MARITIME SAFETY COMMITTEE
109th session
Agenda item 13

MSC 109/13/5
26 September 2024
Original: ENGLISH

Revision of *Required boarding arrangements for pilots* (MSC.1/Circ.1428)

Submitted by IMPA

REQUIRED PILOT TRANSFER ARRANGEMENTS

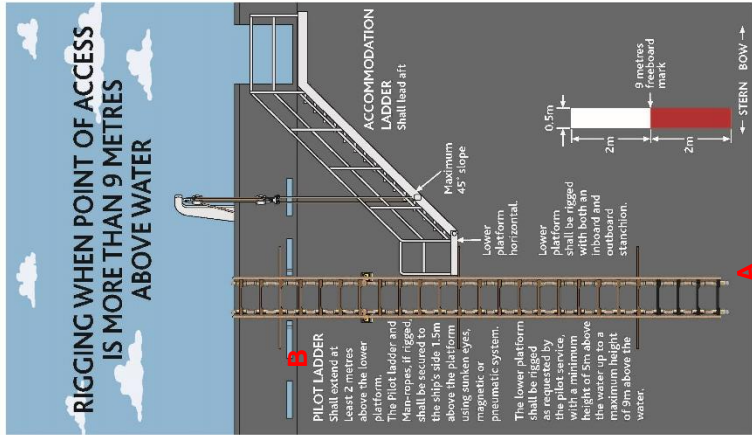
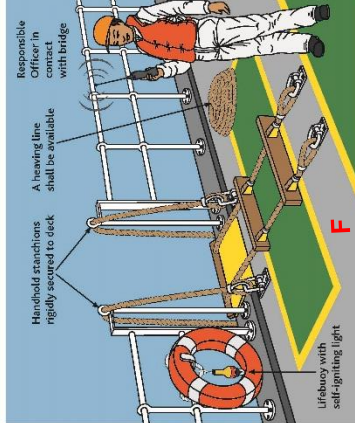
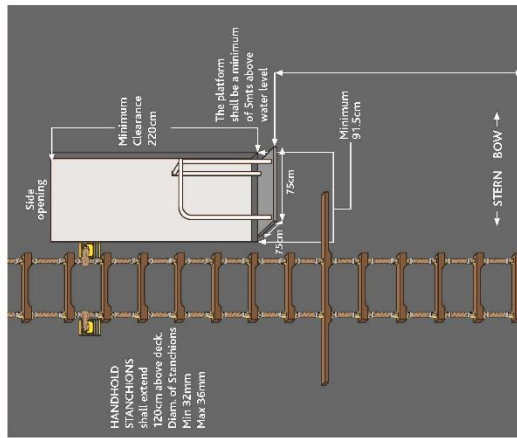
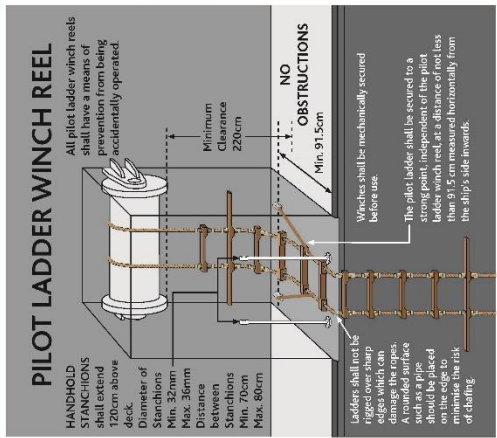
All illustrations of pilot ladders should show compliant finishing of side rope ends.	Refer to "A" on the 1st and 2nd illustrations set out in the annex to the draft revised circular.
For the combination arrangement without a trapdoor, an illustration of the rigging of manropes should be provided.	Refer to "B" on the 1st illustration set out in the annex to the draft revised circular.
Manropes rigged for a trapdoor arrangement should be shown in the illustrations.	Refer to "C" on the 2nd illustration set out in the annex to the draft revised circular.
For ship-side door arrangements, the stanchions should be illustrated to include secured at a secondary position above the deck.	Refer to "D" on the 2nd illustration set out in the annex to the draft revised circular.
For combination arrangements, it should be indicated that magnetic or suction means of hull securing of accommodation ladders might be used as an alternative to a pad eye.	Refer to "E" on the 1st and 2nd illustrations set out in the annex to the draft revised circular.

Illustration of a pilot transfer arrangement on a ship should be without a bulwark, including the rigging of manropes.	Refer to "F" on the 1st illustration set out in the annex to the draft revised circular. The bulwark arrangement will be available via the QR Code.
Align terminology with the terminology used in the draft new performance standards.	Refer to all illustrations set out in the annex to the draft revised circular. Except "by the manufacturer", which was retained when referring to securing pilot ladders at intermediate lengths ("G" on the 1st illustration). It is necessary to reflect that the mechanical device used is one that a manufacturer has specifically designed to secure pilot ladders at intermediate lengths. This is consistent with paragraph 6.3 of the draft performance standards for pilot transfer arrangements (NCSR 11/19/Add.1, annex 9).
The "Non-compliant practices" illustration was useful information and should be included.	Refer to "H" on the 1st illustration set out in the annex to the draft revised circular.

Pilot ladders shall only be secured at intermediate lengths by a device designed by the manufacturer for that purpose, or a rolling hitch. No other method is acceptable. **G**

Accommodation ladder shall be secured to ship's side (using stunkn-eyes or pneumatic system) **E**
